APPENDIX C6 COMMENTS RECEIVED

SCOPING PHASE

LIMESTONE SOLAR PV1 AND LIMESTONE SOLAR PV2 FACILITIES NEAR DANIELSKUIL, NORTHERN CAPE PROVINCE (DEFF Ref. Nos.: To be issued)

COMMENTS ON THE DRAFT SCOPING REPORT FOR THE PROPOSED DEVELOPMENT OF THE UP TO 150MWp LIMESTONE PHOTOVOLTAIC (PV 2) FACILITY AND ASSOCIATED INFRASTRUCTURE, NEAR DANIELSKUIL, WITHIN THE KGATELOPELE LOCAL MUNICIPALITY, NORTHERN CAPE PROVINCE

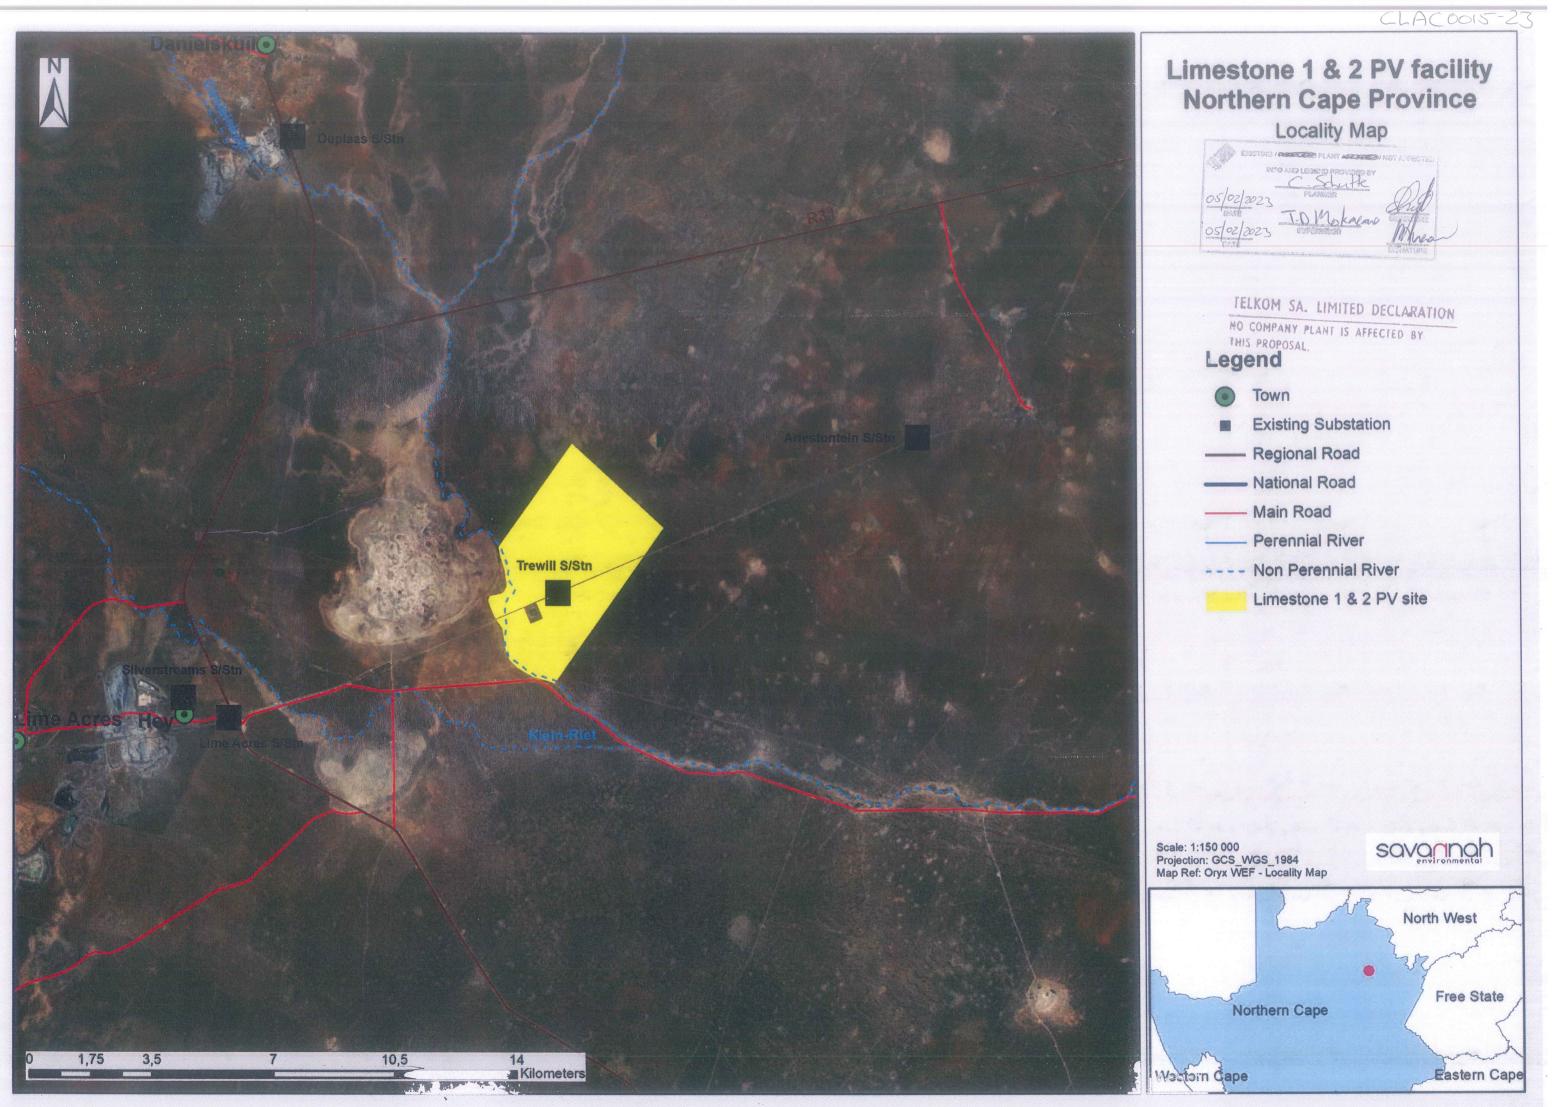
With reference to your above- mentioned application, I hereby confirm that the proposed work installation is approved in terms of Section 29 of the Electronic Communications Act No. 36 of 2005 as amended.

No infrastructure of our Client (Openserve) will be affected by this proposal. We did our utmost to ensure that we indicate our route as accurate as possible and should you discover any of our cables that is not on the sketch please stop and contact us immediately to arrange a site meeting. In the event that our cables are exposed and damaged/stolen by a third party the damages will be repaired at the customer's account. Please make use of pilot holes in order not too damage our infrastructure. Therefore any damages occurred during construction of work will be repaired at the customer's account.

Although we are not affected by this proposal, Mr Vivian Groenewald must be contacted at telephone number 081 362 6738 from our Network Field Services. Two (2) weeks prior to commencement of proposed work.

Approval of the proposed route is valid for six months. If construction has not yet commenced within this period, then the file must be resubmitted for approval.

Any changes/deviations from the original planning during or prior to construction must immediately be communicated to this office.
